**Application for Waiver from Construction Standards for Public Water Systems**

Water System Name: Portland Water Bureau

Project or Facility: SW Woods Creek Ct

Construction standard requested to be waived: OAR 333-061-0050 (9)(b) water sewer separation

# Plan Sheet

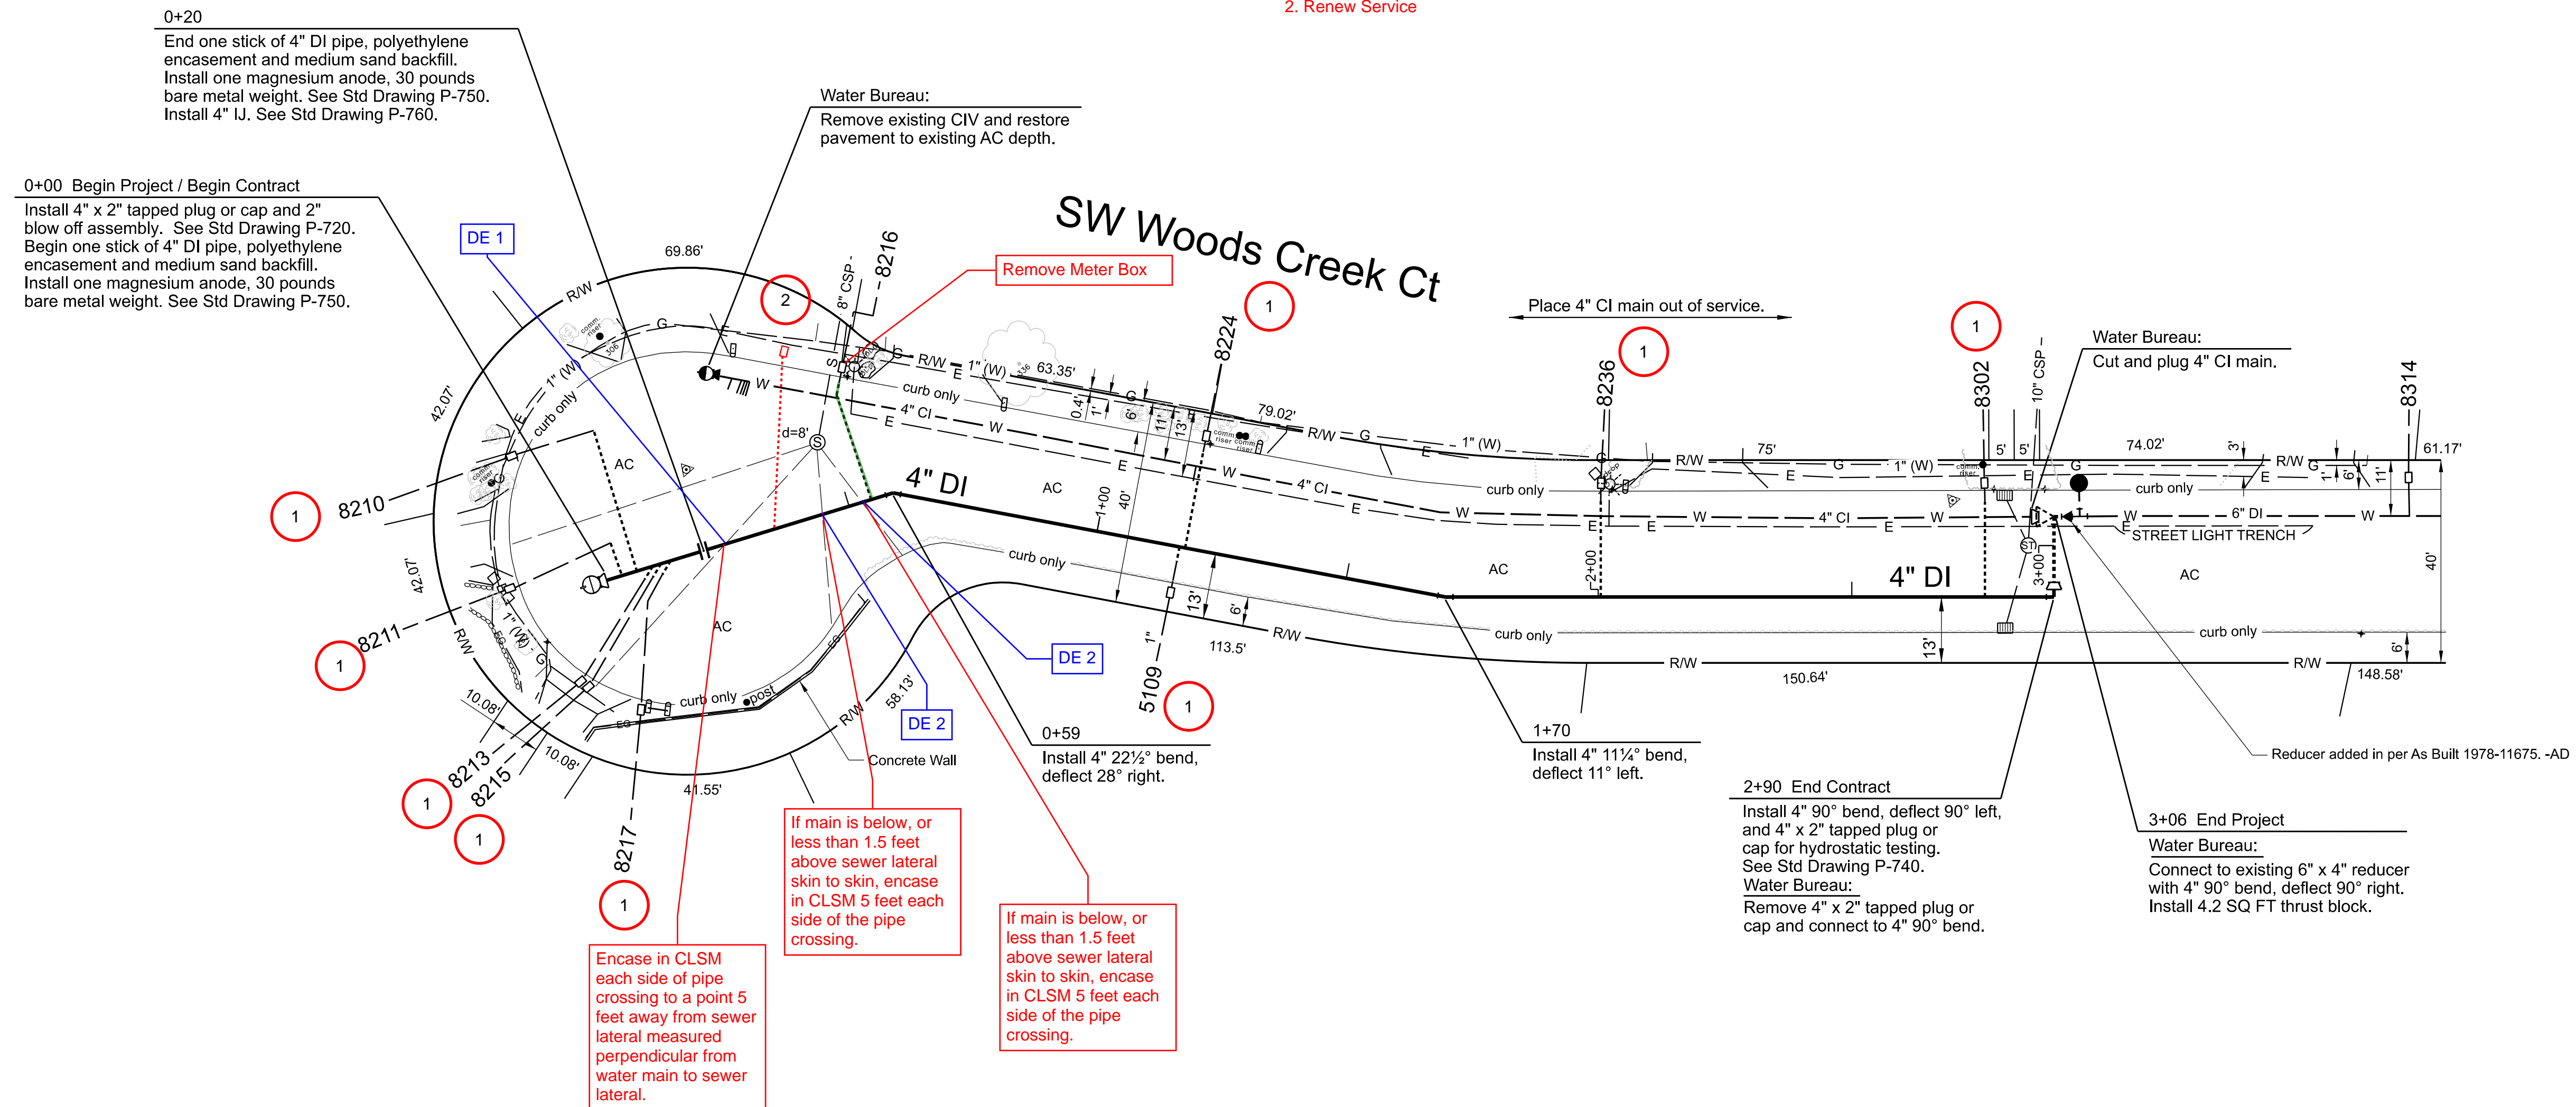
Describe situation that conflicts with the standard. A new water pipe will cross overtop of an existing sewer service at a shallow angle, creating a Zone 2 parallel conflict. See (DE1) on attached plan sheets. The proposed water line will also cross perpendicularly over to existing sewer services of unknown depths. See DE2 on attached plans. If it is determined in the field that there is less than 1.5' vertical clearance, these will also be crossing conflicts.

Describe proposed alternate measure that provide adequate protection to public health and safety. The proposed water pipe will be encased in CLSM for the areas it is within 5' horizontally from the existing sewer. If required, the waterline will also be encased for 10' on either side of the sewer lateral crossings.

☒ Plan Review Coordinator's notes: Proposed encasement with CLSM is an appropriate remedy for the Zone 2 conflict.

☒ Approved      Comments:
